DILAPIDATION REPORT

Sample Property

08/09/2026

4.1.2 Brickwork

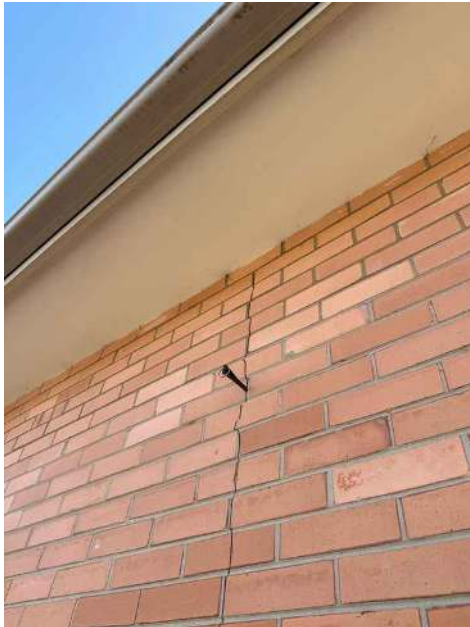
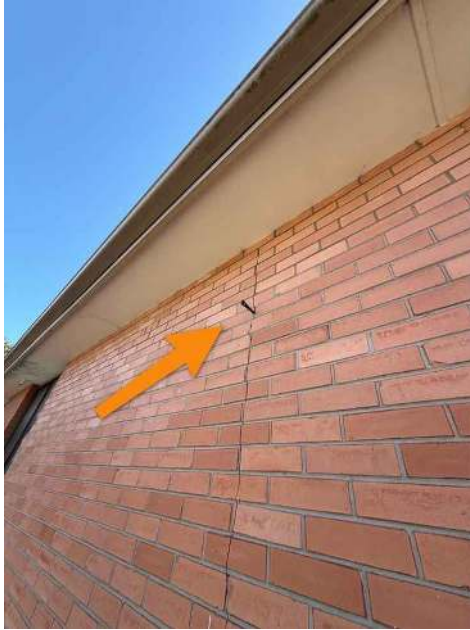
**BRICKWORK CRACKING – GREATER THAN 4.5 MM**

Cracking was noted to the depicted brickwork, measuring greater than 4.5 mm at the highest safely accessible measurement point. The cracking appears to widen further along the higher brick courses. Refer to the accompanying photograph identifying the location at which the measurement was taken.

It could not be established during this inspection whether the cracking was present prior to the commencement of the adjoining excavation works. Based on the visible cracking pattern and direction, there is no clear indication that it is directly associated with the adjoining excavation; however, causation cannot be determined from visual inspection alone.

Given the extent of the cracking and the nearby excavation works, assessment by a suitably qualified structural engineer is recommended to determine its significance, likely cause and whether further investigation, monitoring or rectification is required.
